THIRD NOTICE OF DEFICIENCY FOR THE EXIDE TECHNOLOGIES, VERNON FACILITY PART B PERMIT APPLICATION, REVISION 7 PREPARED BY ADVANCED GEOSERVICES CORPORATION, DATED JANUARY 2013, U.S. EPA ID NUMBER CAD 097854541

SUBJECT: REVIEW OF THE CLOSURE AND POST CLOSURE
CARE COST ESTIMATE FOR PERMIT RENEWAL AND
BANKRUPTCY COURT CLAIM, EXIDE TECHNOLOGIES,
VERNON, CALIFORNIA, SITE CODE 300214

SUBJECT: Review of Section 12 (Closure Plan) of the Part B
Application, Revision 7
Exide Technologies, Inc. Site
2700 South Indiana Street
Vernon, California 90058
Prepared by Advanced Geoservices Corp. (AGC)

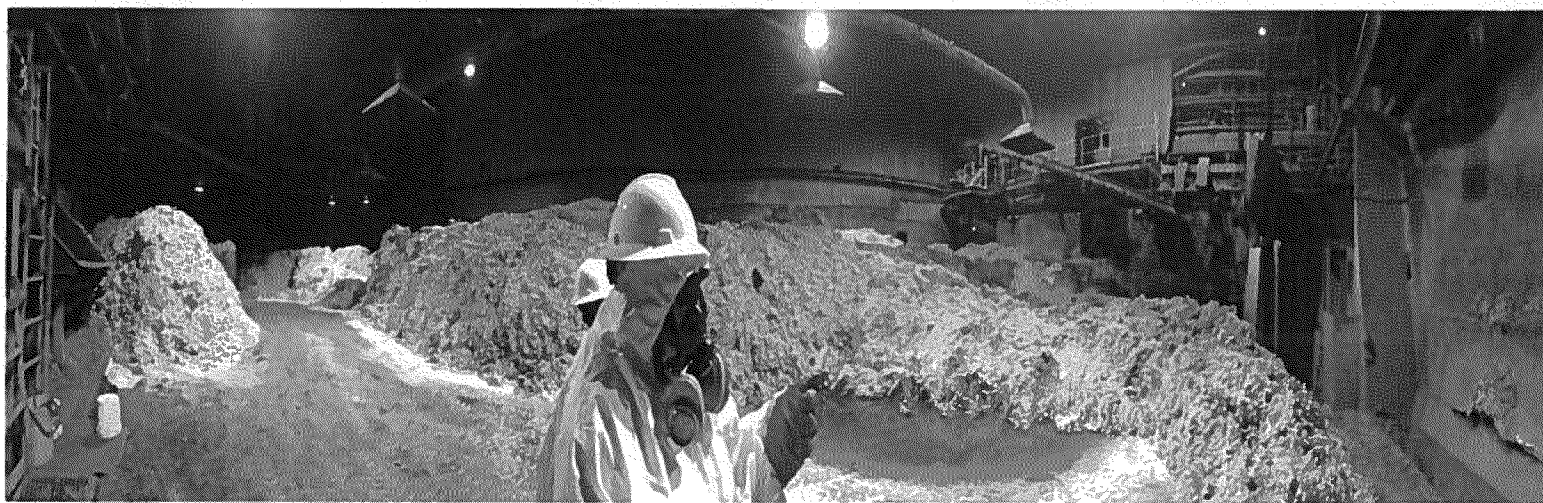
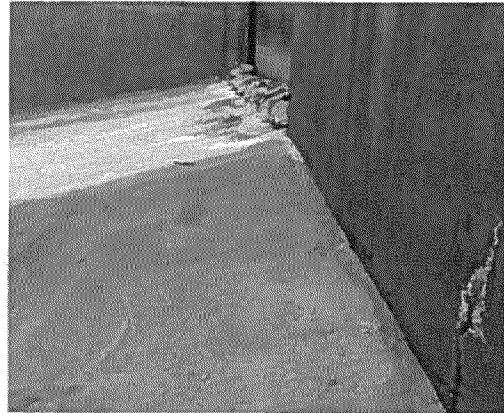
The Closure Cost Estimate contained calculation errors that lead to large discrepancies in the hazardous waste volumes and closure costs. For example, the Closure Cost Estimate states the following:

$$622 \text{ cy} / 3.7 \text{ drum/cy} = 168 \text{ (55-gallon drums),}$$

However, the correct equation is:

$$622 \text{ cy} * 3.7 \text{ drum/cy} = 2,302 \text{ (55-gallon drums).}$$

These discrepancies resulted in a significant under estimate of the closure costs by several million dollars. The closure cost estimate shall be revised to include accurate volumes and cost calculations.

RMPS Paste Thickening Unit 12 – “Santa Maria”

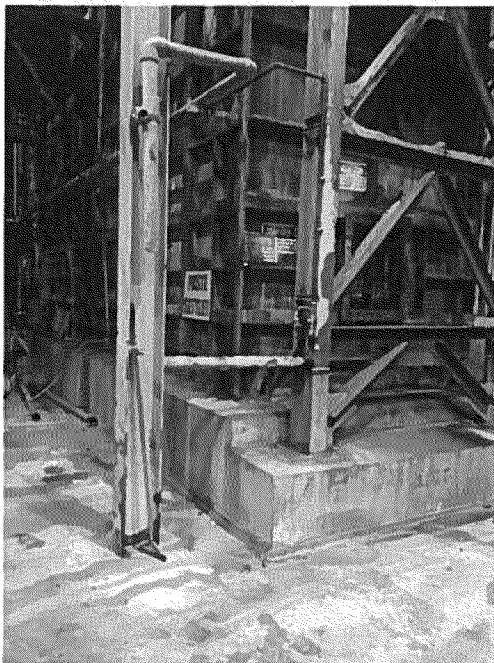
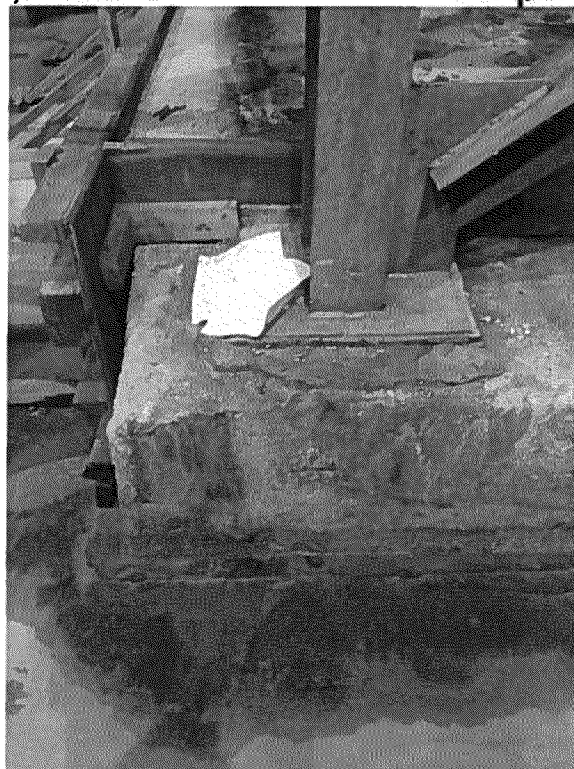
4. During a **site inspection** DTSC staff found: gross contamination of the buildings and subsurface drainage systems, evidence of spills inside the containment buildings on the concrete floor and running out from spaces under the containment building doors, and corrosion and cracking of the metal and cement structures as shown in the following photographs and photographs included in Attachment A.

Based on these observations DTSC staff determined that demolition of the buildings and removal of at least five feet of contaminated soil under the buildings would be necessary for the closure of the facility pursuant to 22 CCR 66264.112(b)(4). The Closure Plan and Cost Estimate shall be revised to include the demolition and disposal of the structures using the current costs provided in the following detailed comments, unless sample results indicate the soil is clean and the structures can be decontaminated and certified by a California Structural Engineer to be able to withstand the Maximum Considered Earthquake.

**Reverb Furnace Feed Room, Corridor, and Blast Feed Room
(Containment Building)**

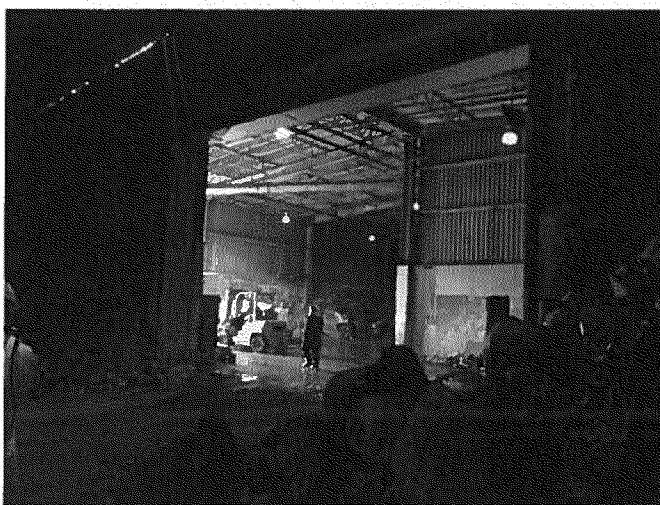
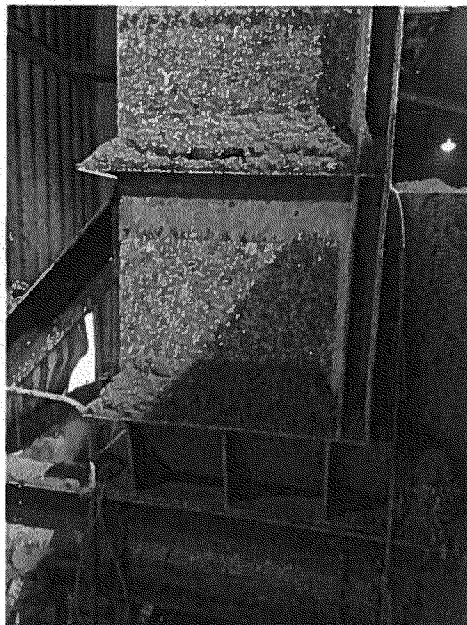
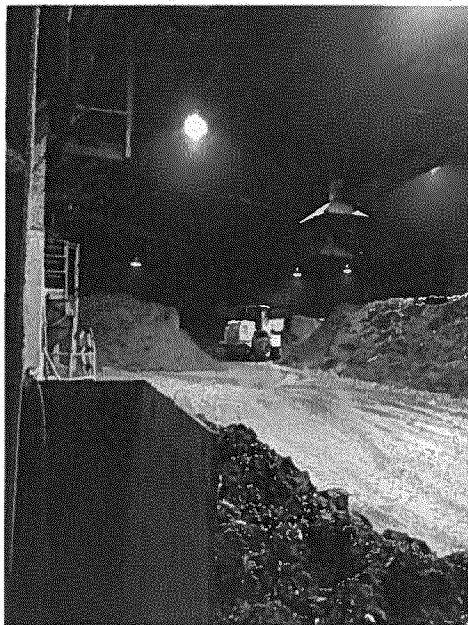
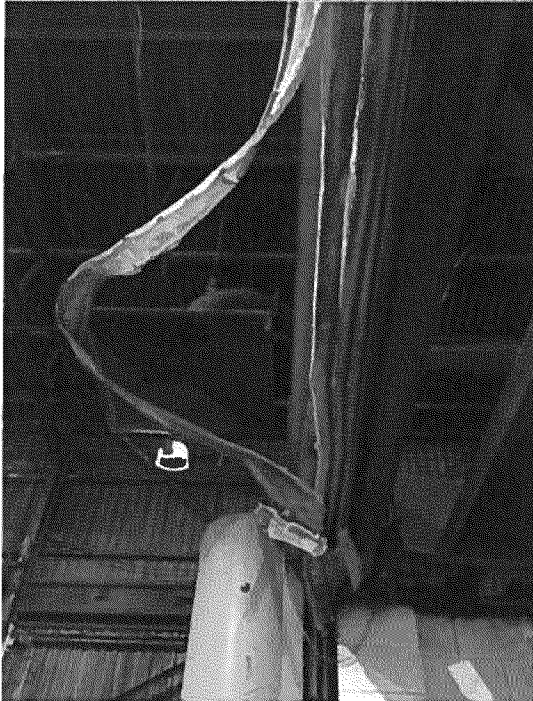
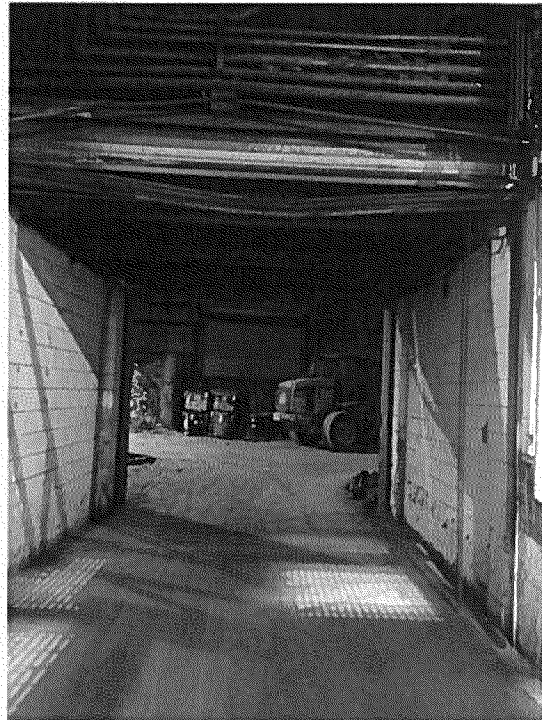
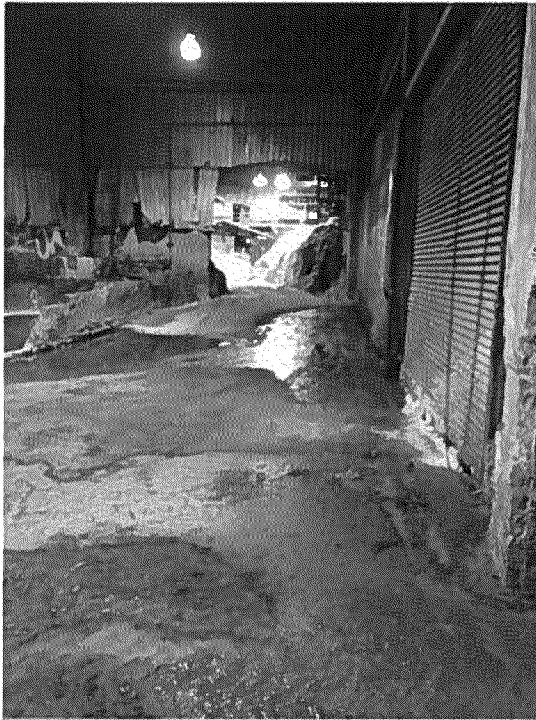
Operating a containment building requires owners and operators to follow the requirements of California Code of Regulations, title 22, sections 66264.1100 through 66264.1102. During the DTSC site visit on April 18, 2014, DTSC made several observations of the operations at the Facility. Several factors led DTSC to believe that the requirements of these regulations should apply to the entire building structure including the feed rooms, the RMPS Building, the Baghouse Building, the Smelter Building, and the Finished Lead Storage Building. The factors that support the application of these requirements are: 1) there exist interior openings between all the buildings which essentially create one large building where free transfer of airborne particulates/constituents can occur; 2) the roll-up doors that could close off the feed rooms/corridor from the rest of the buildings are non-functional and damaged; 3) there is significant visual evidence of feed materials and liquids transferring between buildings through interior doors and corroded sheet metal walls.

Visual evidence of the transfer of solid waste materials and liquid waste through exterior roll-up doors, through corroded sheet metal on exterior walls, and into the base of damaged concrete, suggests that the requirements of the cited regulations may not be met by Exide. Additionally, holes in ceilings and gaps between roof structures and walls

Refining/Receiving Kettles

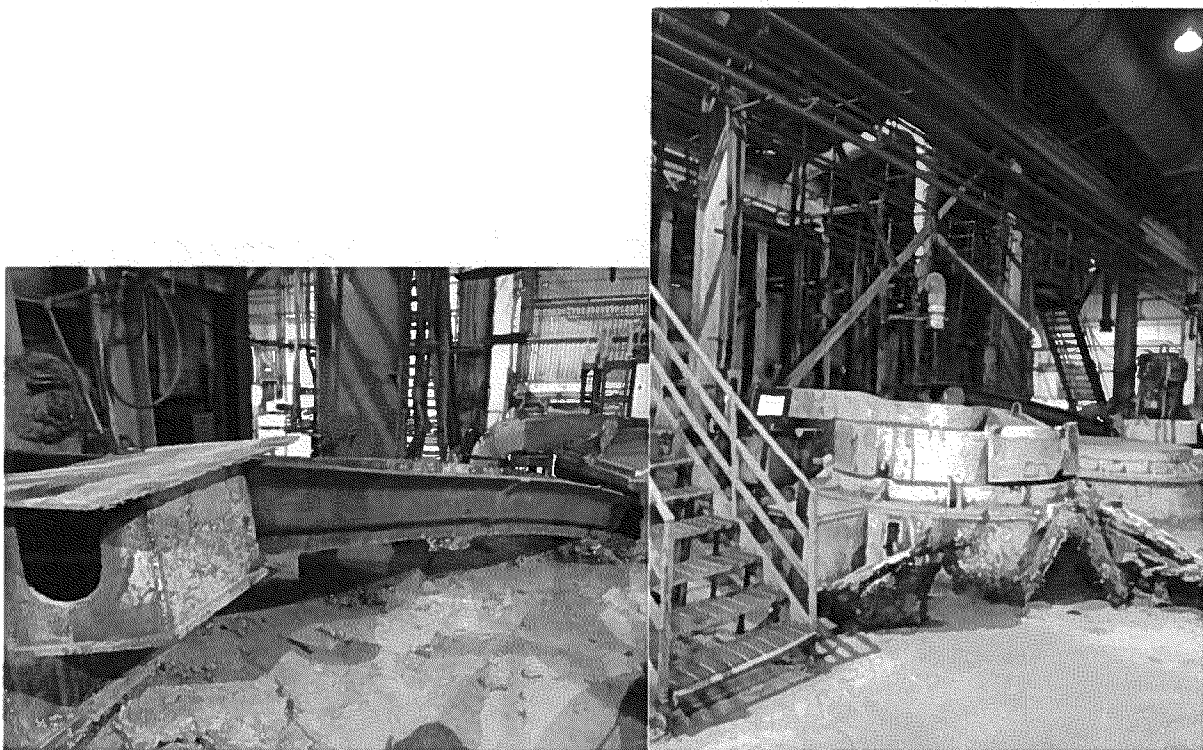
In the Application, there is no discussion of the operation of the receiving and refining furnaces (as referenced in the June 24, 2009, SCAQMD Title V Permit to Operate) as hazardous waste management devices/units. As noted in the DTSC site visit on April 18, 2014, both the Reverb Furnace and the Blast Furnace feed receiving kettles via launders. These receiving kettles in turn feed refining kettles, at which point the molten lead is transferred to the various molds to make the "hogs," "pigs," and "billets." The Application states: "The lead tapped from the permitted Reverb Furnace is collected in the soft lead refining kettles for **further processing to remove any remaining metallic impurities**" and "During the process of recovering lead from the permitted Blast Furnace, lead is tapped and collected into the hard lead refining kettles **where alloy lead is prepared according to the customer specifications**" (emphasis added). However, the receiving and refining kettles are not included as hazardous waste management devices/units in the Application.

In previous iterations of the Application, these units were included. Exide must include these units in the Application and all drawings must be updated to include these processes.

Further, the Closure Cost Estimate for the Facility must also be modified to reflect the closure of the receiving and refining kettles.
